Equipment Environmental Qualification Review

Responses to

Draft Interim Technical Evaluation Report

Zion Station - Units 1 & 2

Schematic Diagrams for the Residual Heat Removal Pump 1B unit cooler and the Safety Injection Pump 1A unit cooler are shown on Drawing 22E-1-4840, Pages AV2 and AV3 respectively. Copies of these drawings are enclosed for your use.

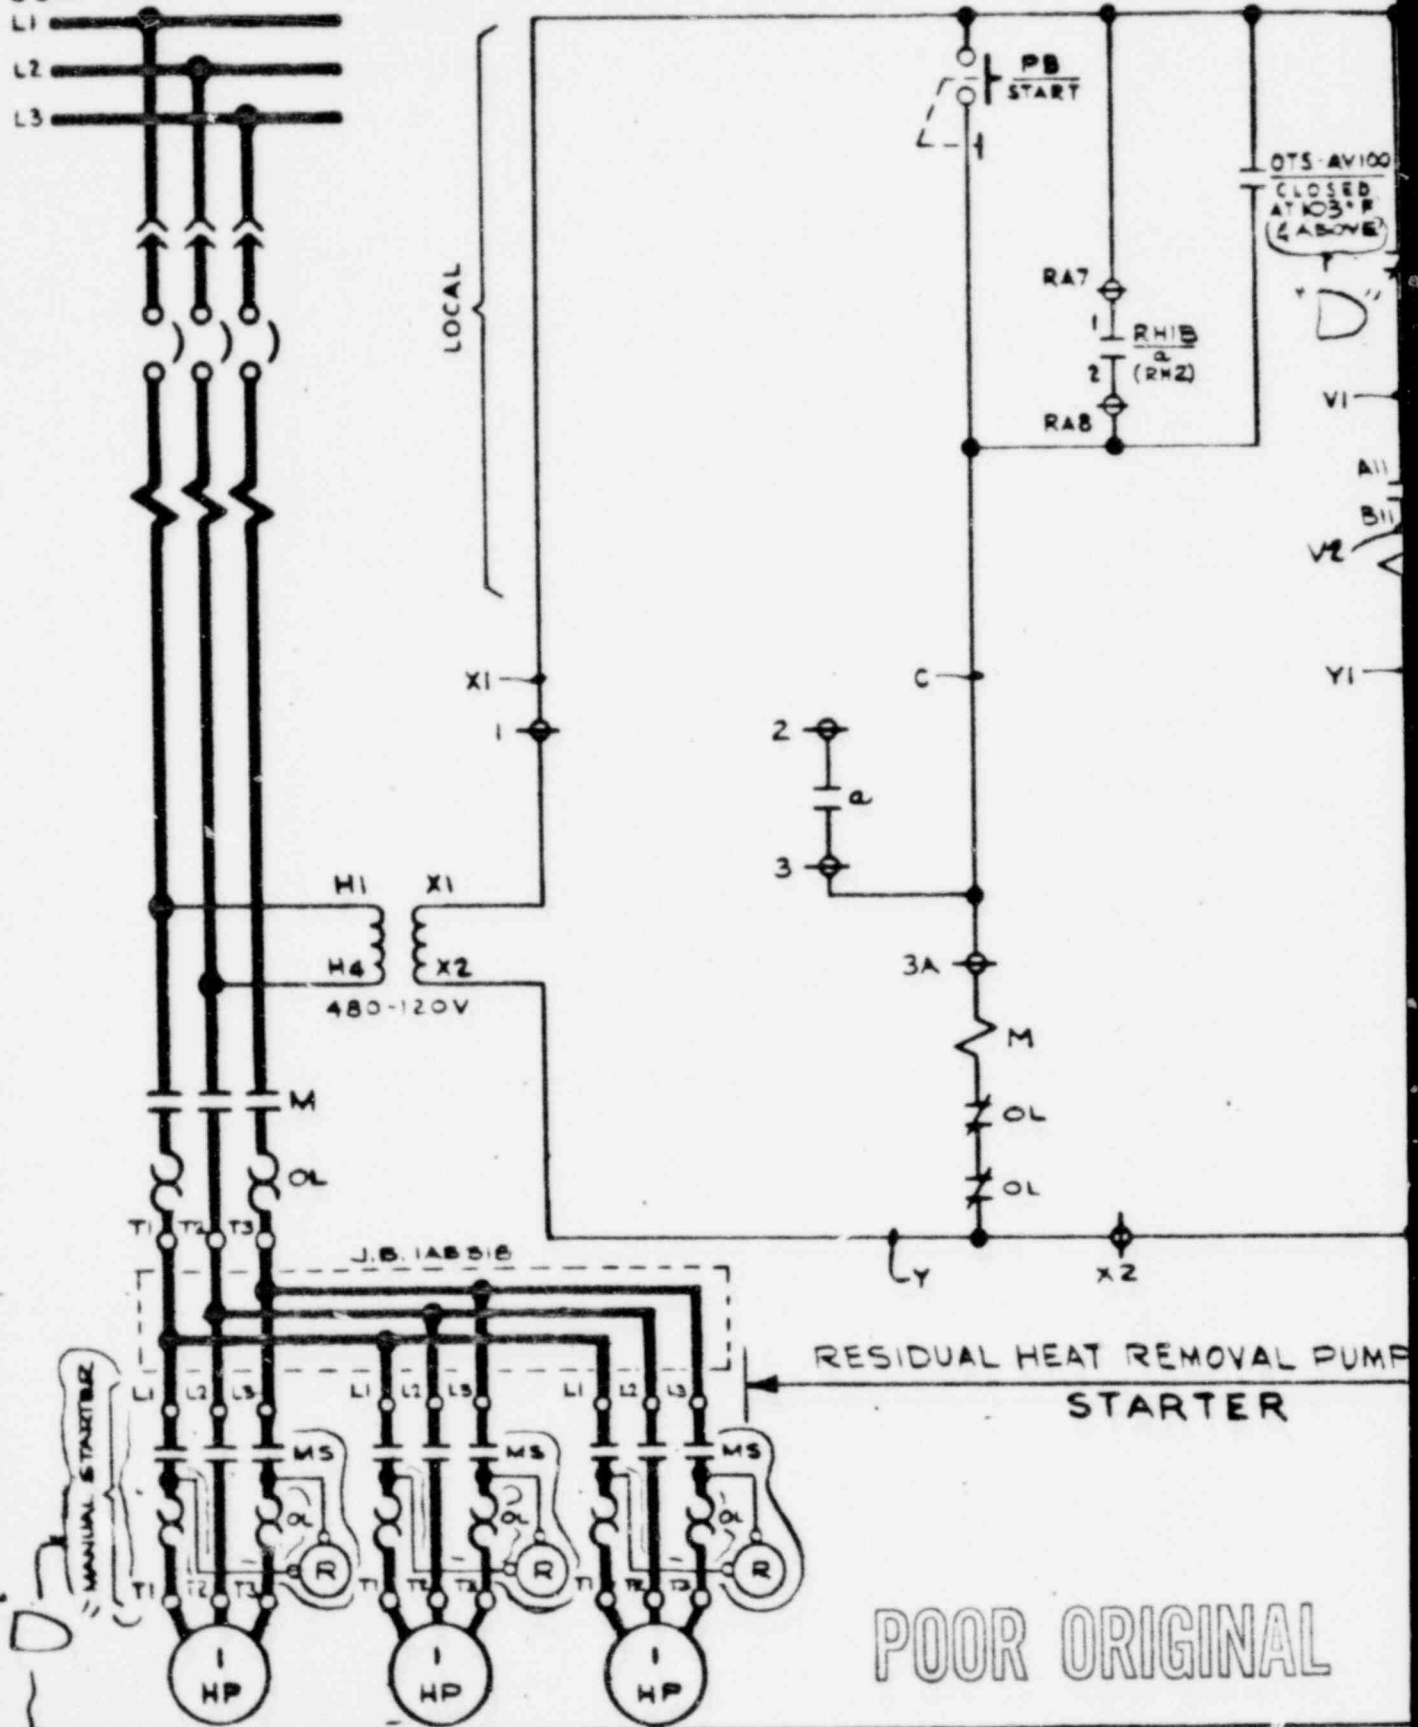
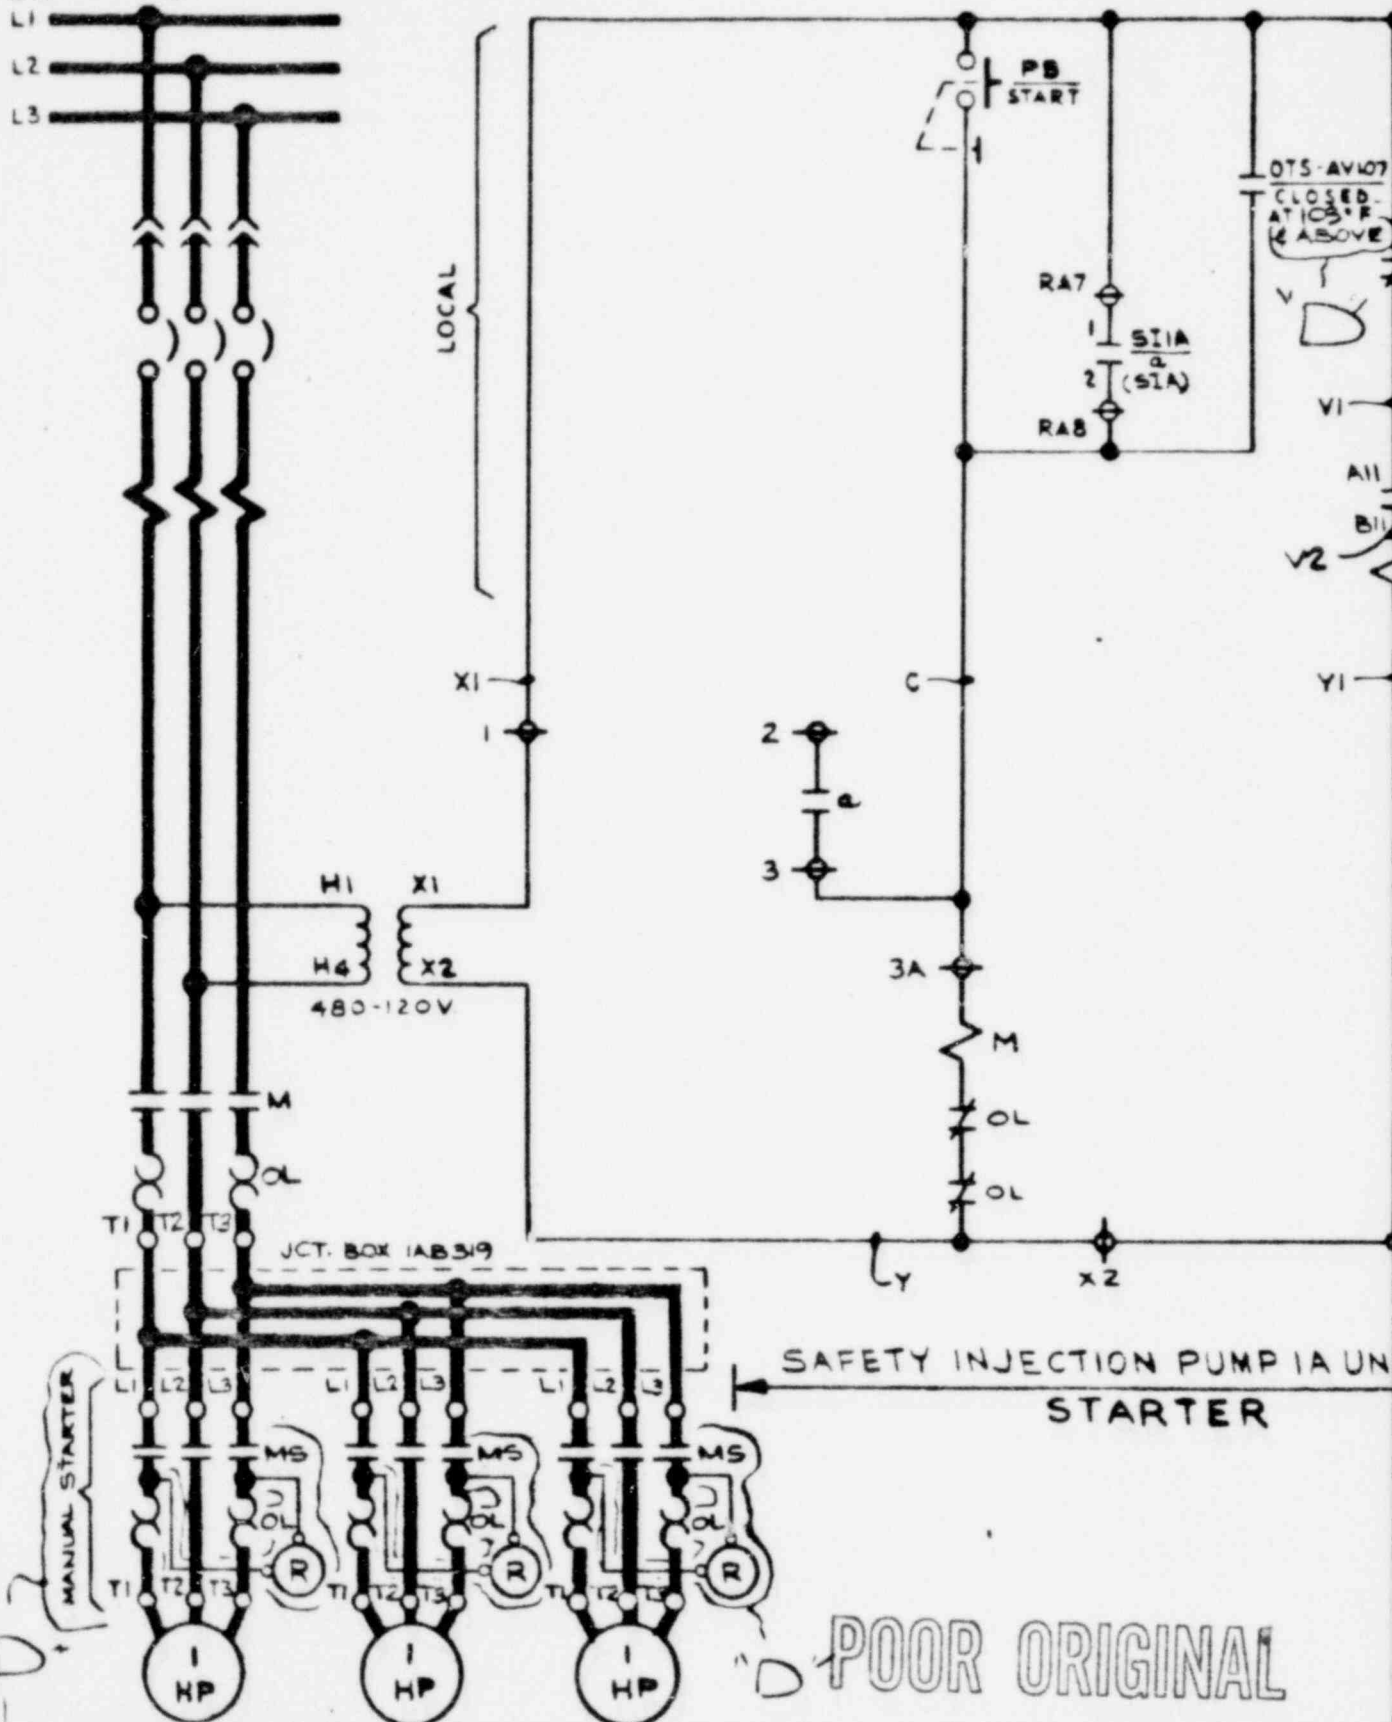
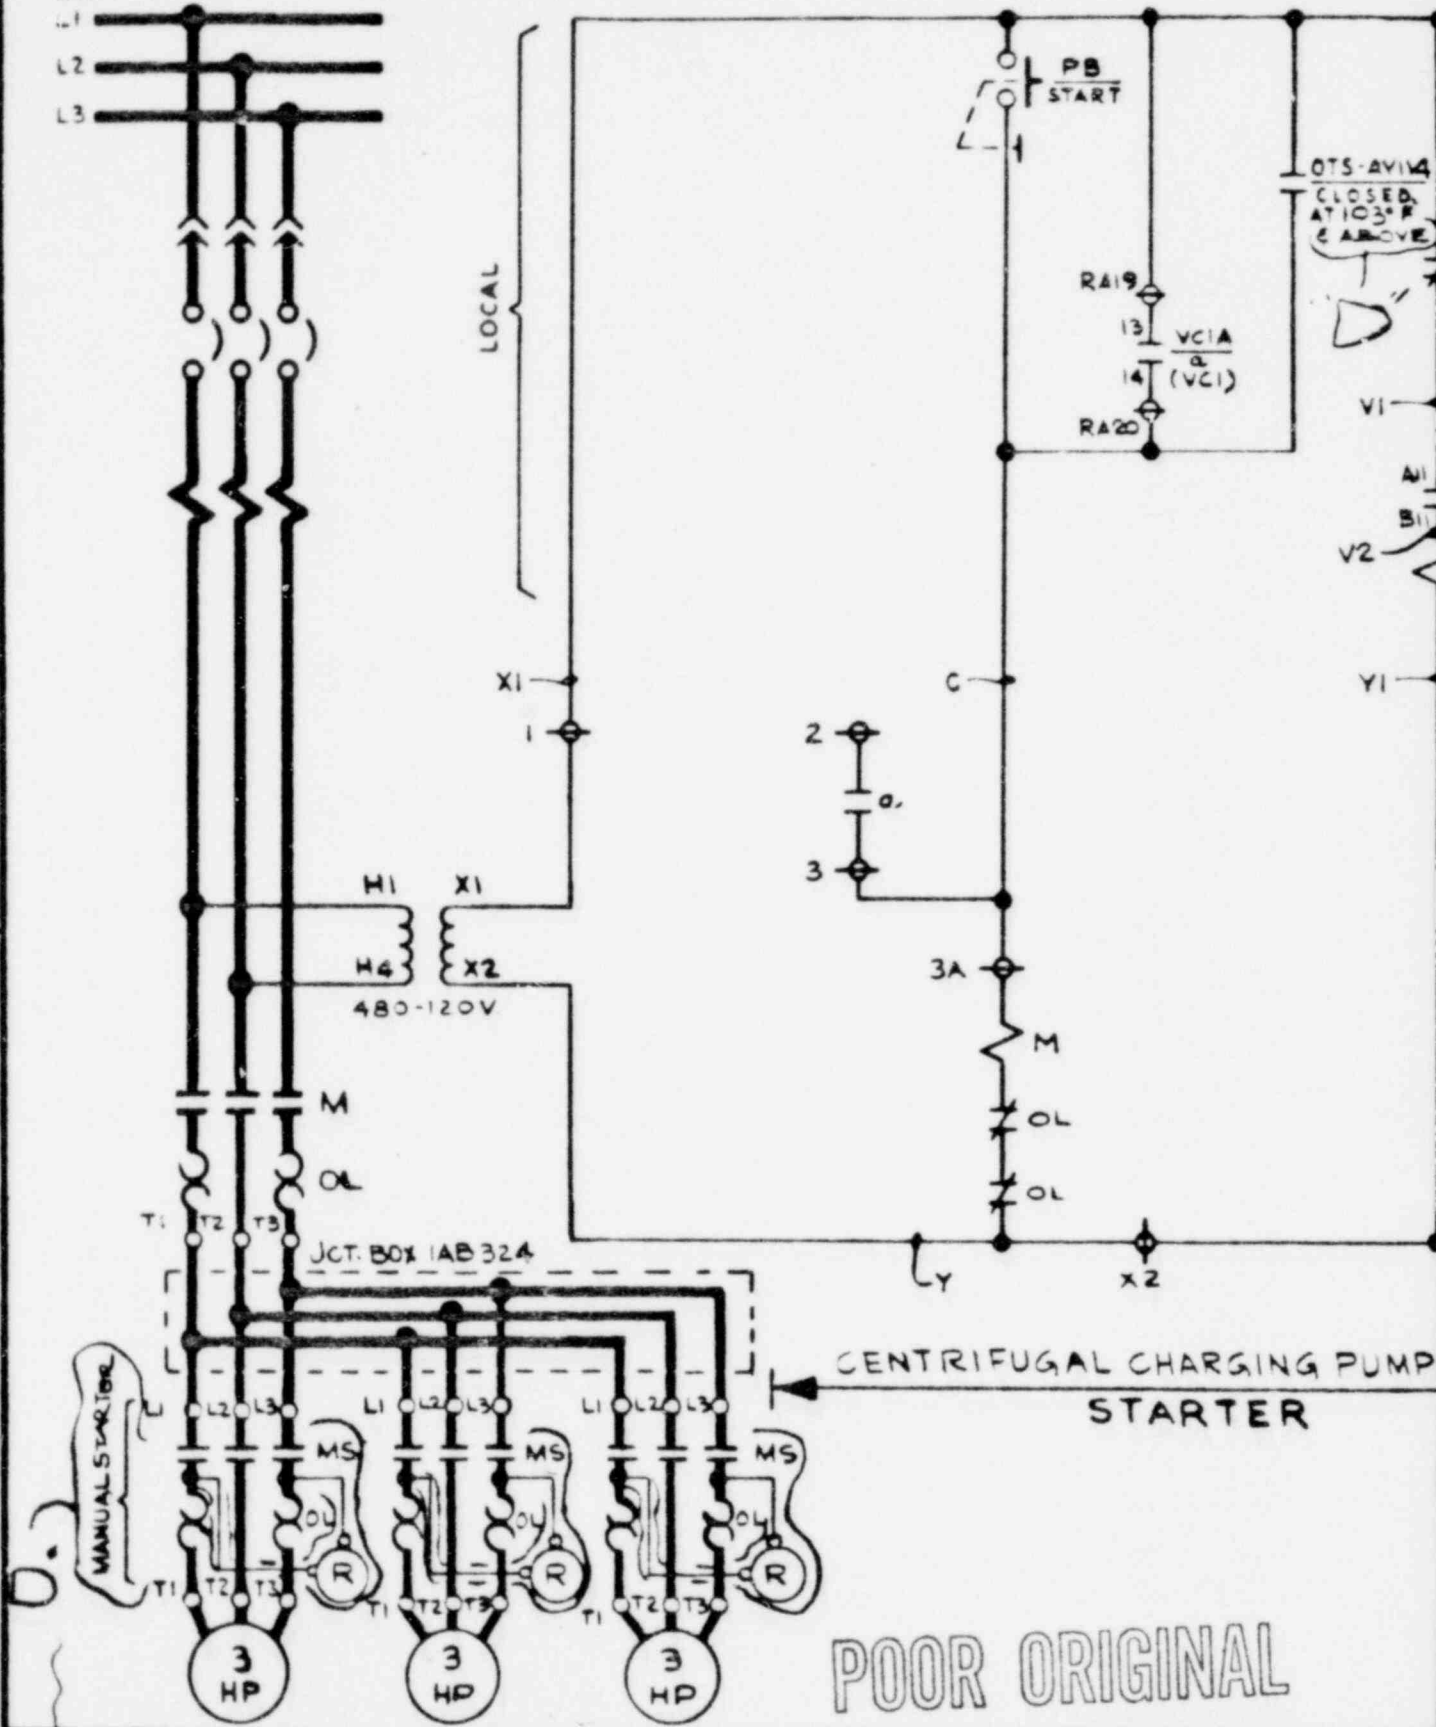
These components are not required to operate after a LOCA or HELB. The cubicle coolers are started automatically, whenever their associated safety system pump is started. The control circuit for the cubicle coolers associated with Centrifugal Charging Pump 1A (shown on Drawing 22E-1-4840, Page AV7) is typical of the control circuit for all the pumps listed above.

The thermostat (OTS-AV114), as well as the pushbutton shown on the schematic (Page AV7), do not perform a safety function and their failure will not impair the operation of the cubicle coolers. The possible failure modes for the thermostat, as well as the pushbutton, are 1) contacts short together, 2) contacts fail to close (remain open), and 3) contacts short to ground.
